ELLEN DRIVE SANITARY SEWER IMPROVEMENTS

SPRINGFIELD TOWNSHIP MUSKINGUM COUNTY, OHIO

REPLACEMENT OF AN EXISTING VARIABLE GRADE SANITARY SEWER
WITH GRAVITY SANITARY SEWER

NO.	DATE ISSUED	DESCRIPTION	SHEET NOS.
1	10/03/2024	ADDITIONAL MANHOLE (MH 13) AND PIPE RUN (MH 10 TO MH 13) TO SERVE TWO ADDITIONAL HOUSES	10
2	03/17/2025	CHANGE T/C OF MH 2, MH 3 AND MH 11 PER SURVEY FIELD VERIFICATION	7, 8, 10, 11
3	06/25/2025	CHANGE SEWER ALIGNMENT AND PROFILE FROM MH 4 TO MH 7 PLUS ADD MH 6A TO ELIMINATE CROSSING DRIVEWAYS	7 - 11
4	10/07/2025	UPDATED DEPICTION OF EXISTING WATERLINE IN PROFILE; EXTENDED MH 12 APPROXIMATELY 33.5 FT WEST OF PREVIOUS LOCATION	8, 10, 11

MJE
GJW
07/11/2024
06/25/2025
11" x 17"
PLAN SHEET (1)
07
11

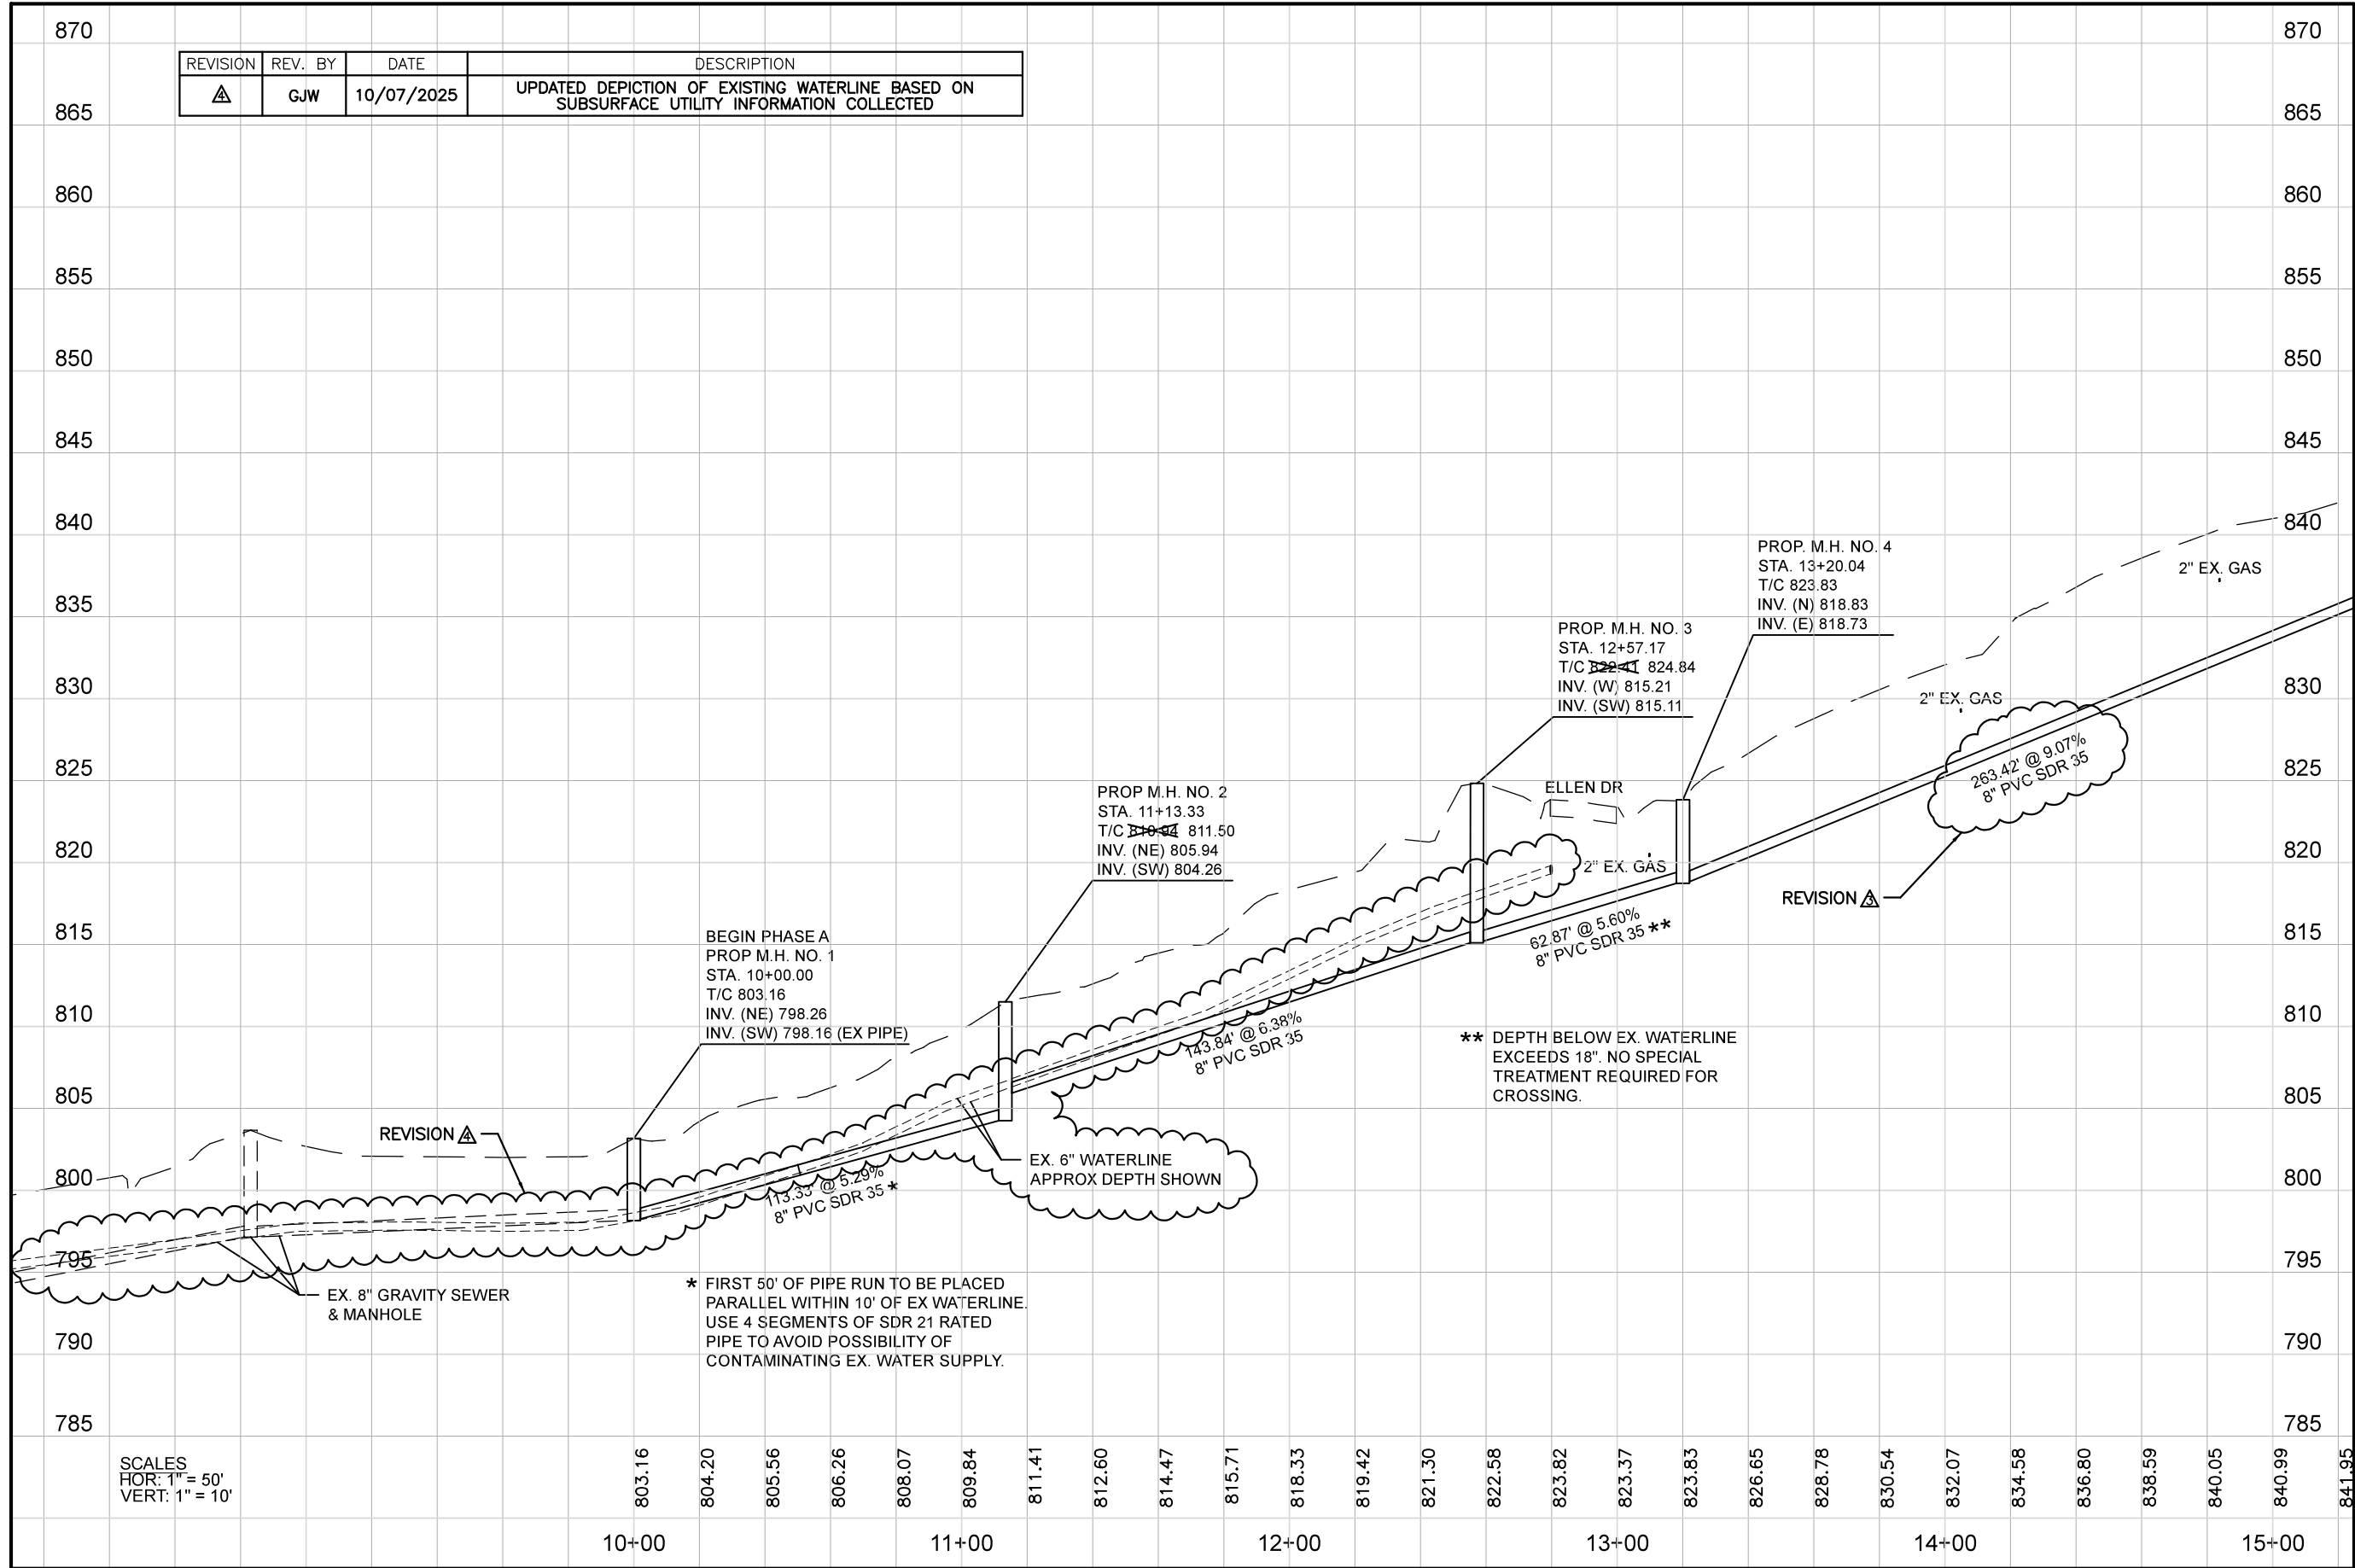
REVISION	REV. BY	DATE	DESCRIPTION
A	GJW	10/07/2025	UPDATED DEPICTION OF EXISTING WATERLINE BASED ON SUBSURFACE UTILITY INFORMATION COLLECTED

SEWER
LINE NO. 1
PROFILE

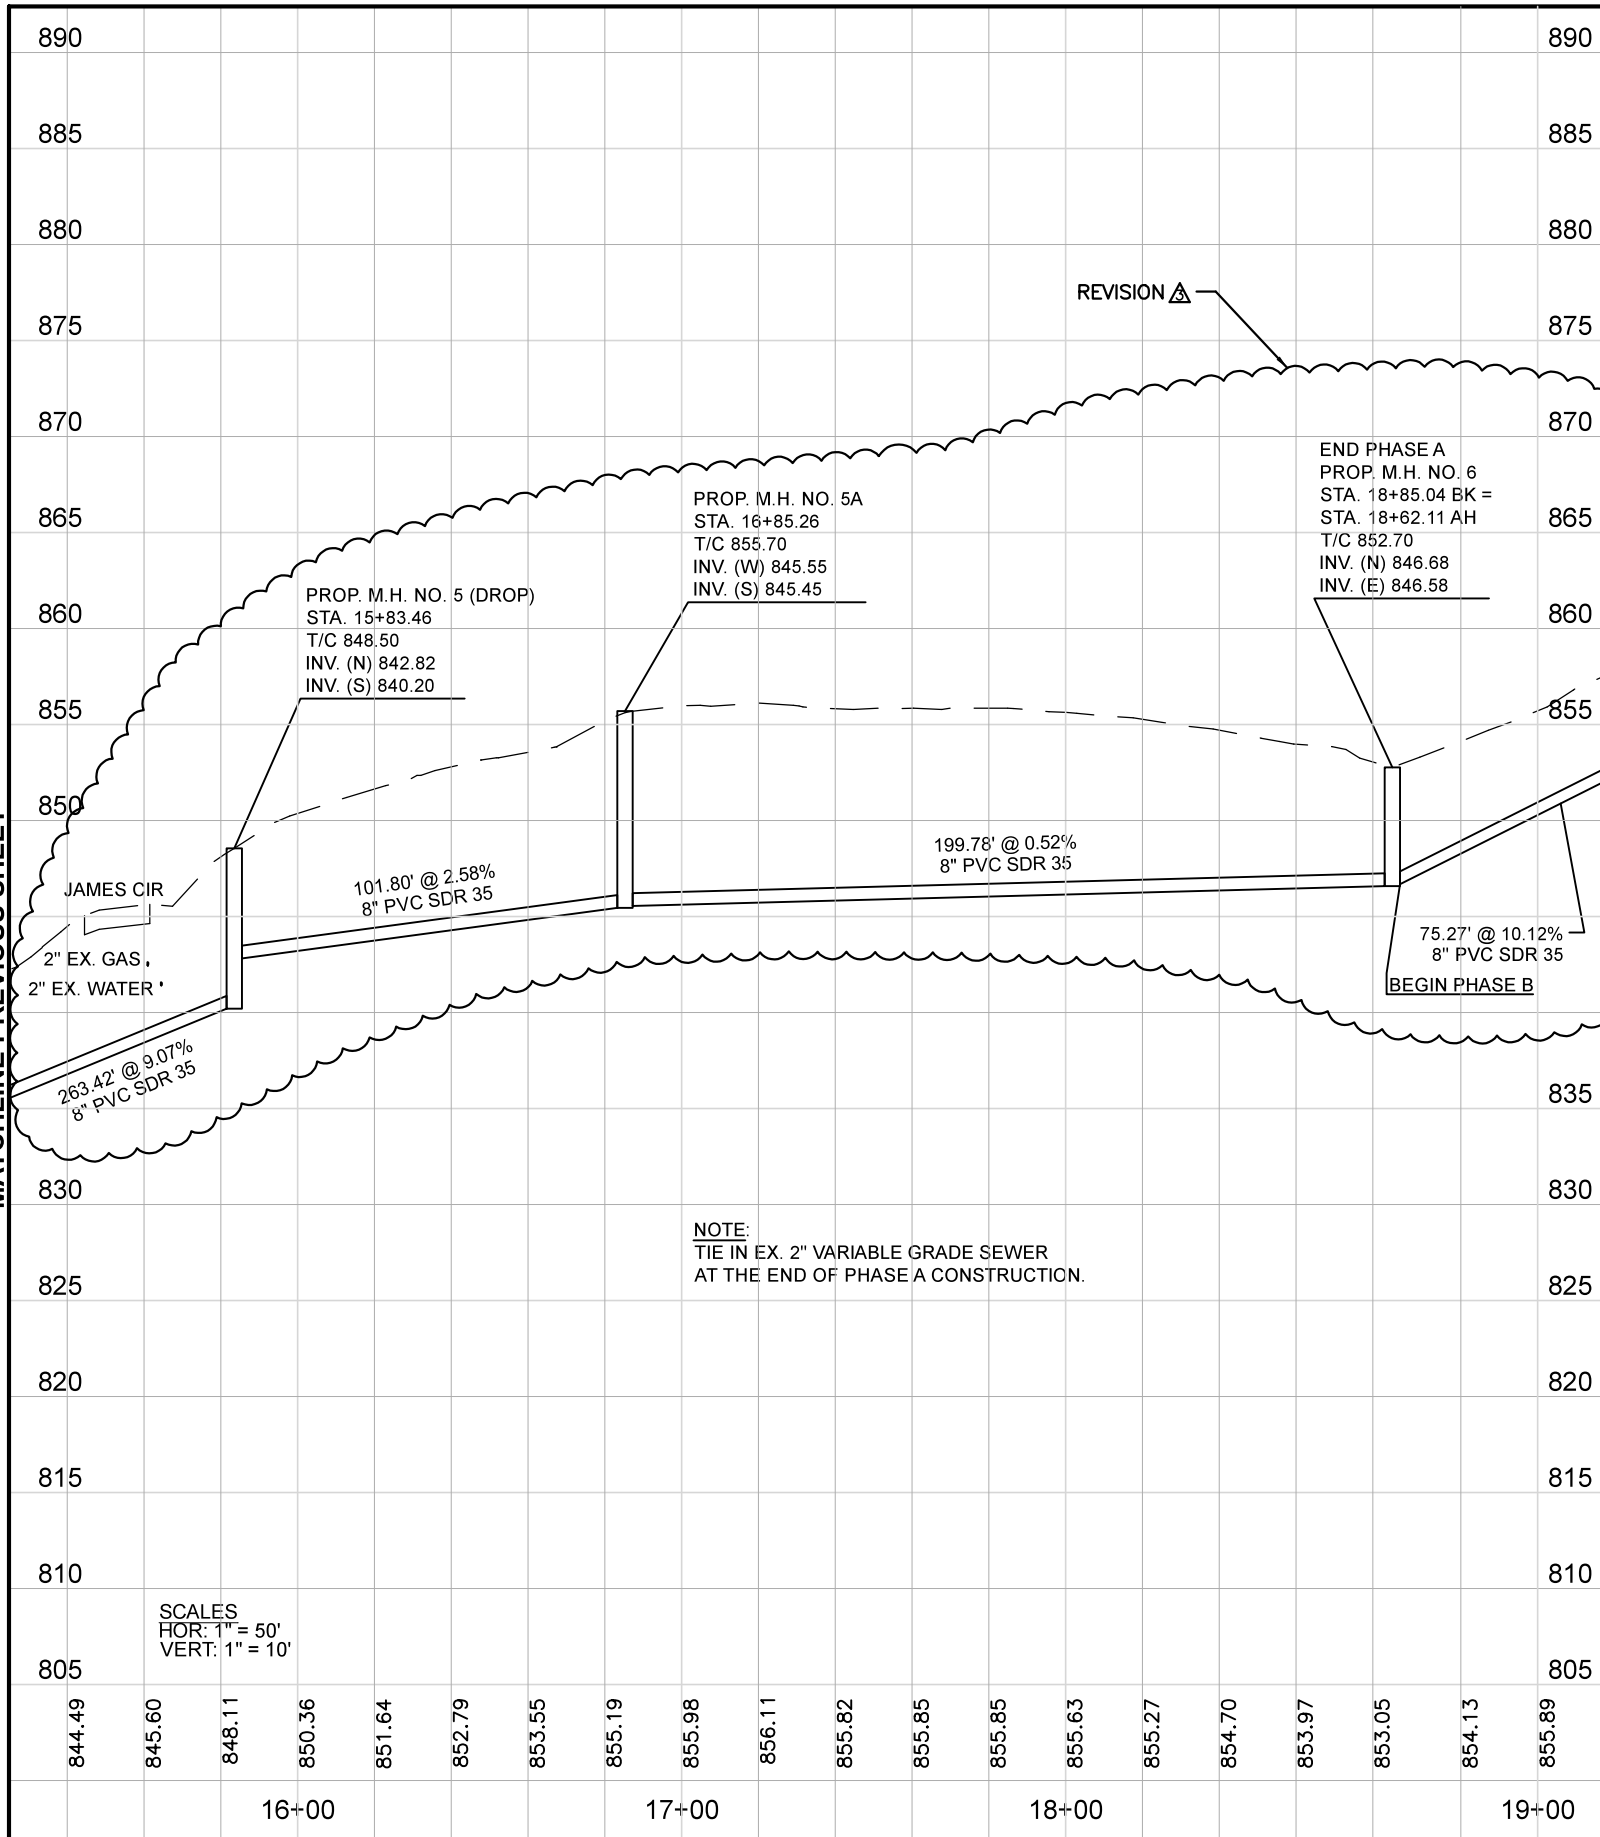
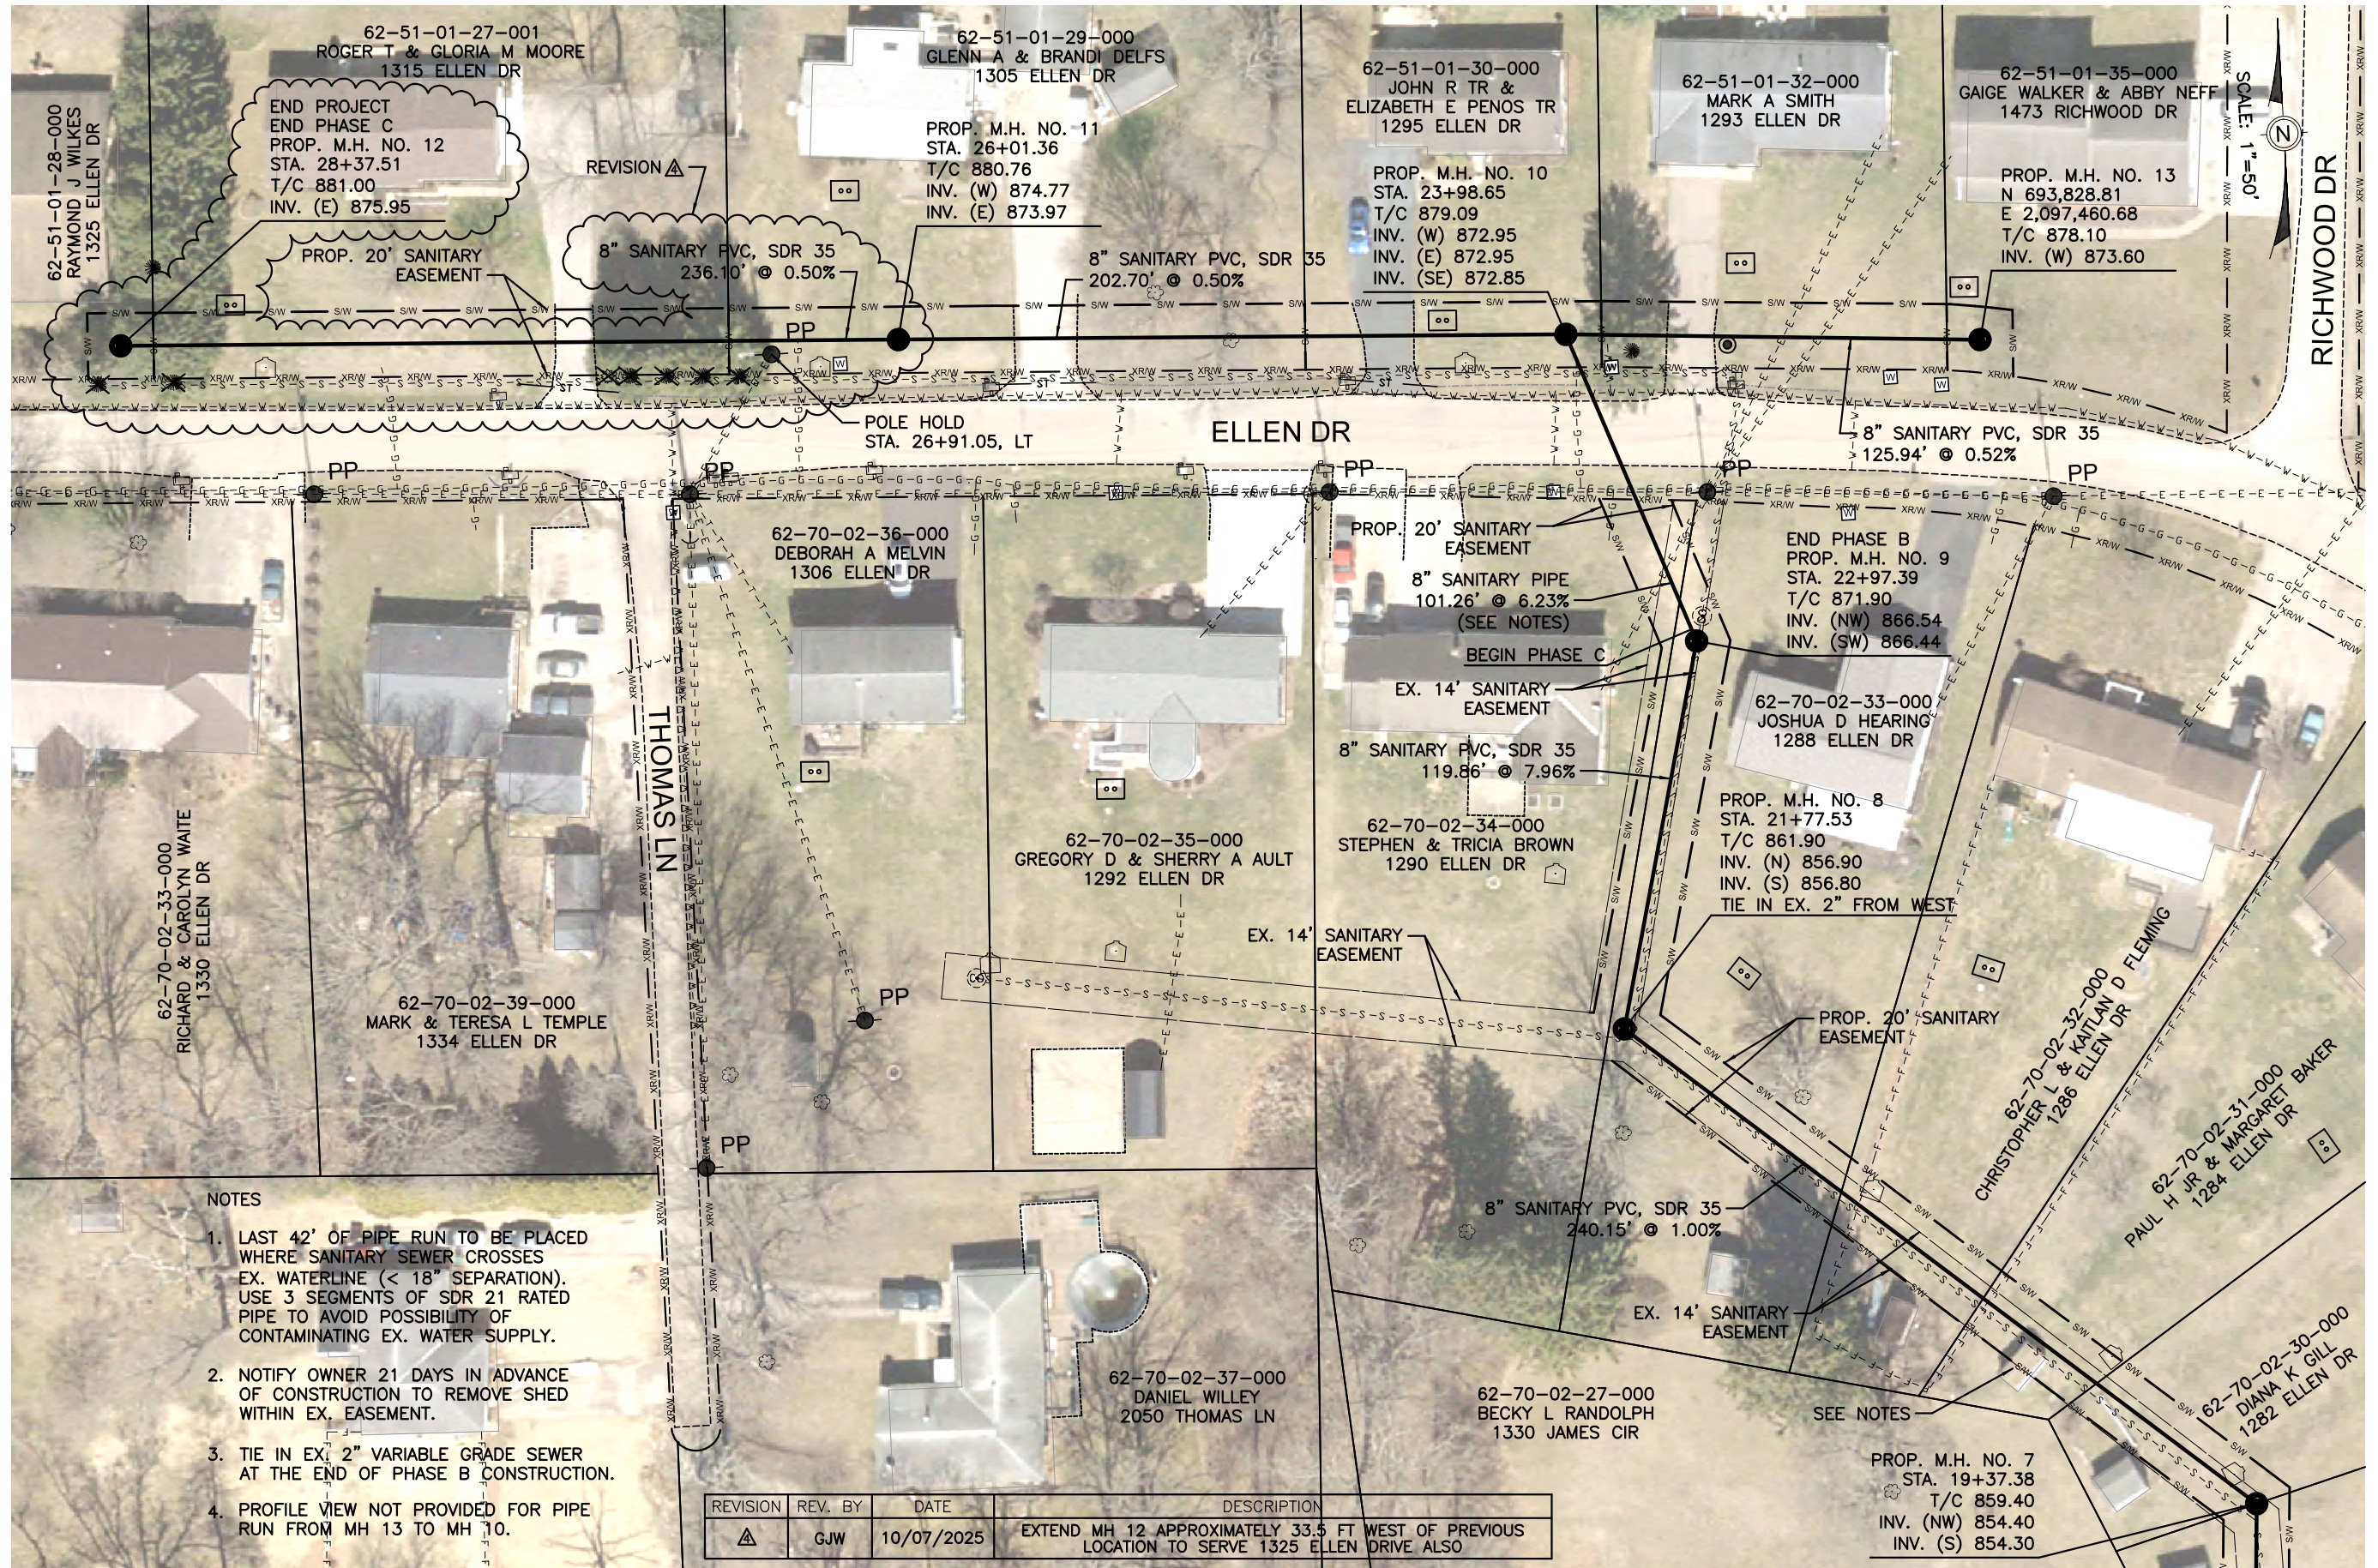
REVISION	REV. BY	DATE	DESCRIPTION
	GJW	06/25/2025	CHANGE SEWER ALIGNMENT AND PROFILE FROM MH 4 TO MH 7 PLUS ADD MH 5A TO ELIMINATE CROSSING DRIVEWAYS

* FIRST 50' OF PIPE RUN TO BE PLACED PARALLEL WITHIN 10' OF EX WATERLINE. USE 4 SEGMENTS OF SDR 21 RATED PIPE TO AVOID POSSIBILITY OF CONTAMINATING EX. WATER SUPPLY.

** DEPTH BELOW EX. WATERLINE EXCEEDS 18". NO SPECIAL TREATMENT REQUIRED FOR CROSSING.
